Subject: Westinghouse Responses to NRC Request for Additional Information (RAIs) on "Optimized ZIRLO™" Topical – Addendum 1 to WCAP-12610-P-A and CENPD404-P-A (Non-Proprietary), TAC No. MB8041

**Westinghouse Responses to NRC Request for Additional Information
(RAIs) On Optimized ZIRLO™ Topical – Addendum 1 to WCAP12610-
P-A and CENPD404-P-A**

Figure 3.1 Effects of Fluence Levels on Mechanical Properties
(ASTM STP 681 - article by K.Pettersson)

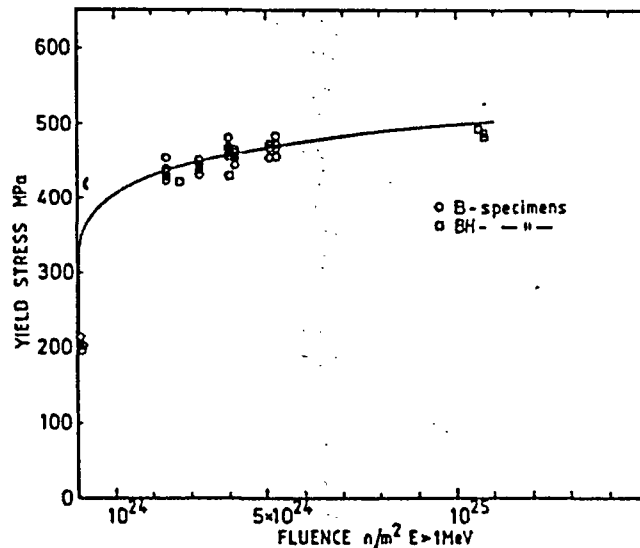
3. Irradiation experience with Optimized ZIRLO™ is discussed in Section 3.5.
 - a. In light of the limited database presented, justify the material properties up to 62,000 MWD/MTU.

The characterization testing reported in the addendum demonstrates that standard ZIRLO material properties currently used in various models and methodologies are applicable to analyses of Optimized ZIRLO. The primary effects of a reduced tin level in ZIRLO are a minor reduction in the un-irradiated mechanical strength and improvement in the corrosion resistance. The higher burn-up levels are associated with higher fluence levels. Since the precipitate structure remains the same for current and Optimized ZIRLO, the past performance of ZIRLO precipitate structure at high burn-ups also is similar to the Optimized ZIRLO condition.

Likewise, with the irradiation strengthening occurring during the initial irradiation, the Optimized ZIRLO performance will be the same as the current ZIRLO performance. The irradiation strengthening that occurs with the initial fuel operation negates the starting differences in mechanical strength. This effect has been reported in the general literature. An early example is found in ASTM STP 681 in an article by K. Pettersson on the effects of irradiation on the mechanical strength of Zircaloy tubes. Figure 3.1 is a copy of one of the figures in the report that shows that irradiation strengthening occurs very early in the initial operating cycle. The data shows that there is an initial period when at relatively low fluence (3×10^{21} n/cm²) the majority of the irradiation strengthening occurs. Data reported in ASTM STP 484 by D.H. Hardy on "The Effect of Neutron Irradiation on the Mechanical Properties of Zirconium Alloy Fuel Cladding in Uniaxial and Biaxial Tests" indicates that (a) strengthening occurs during the initial
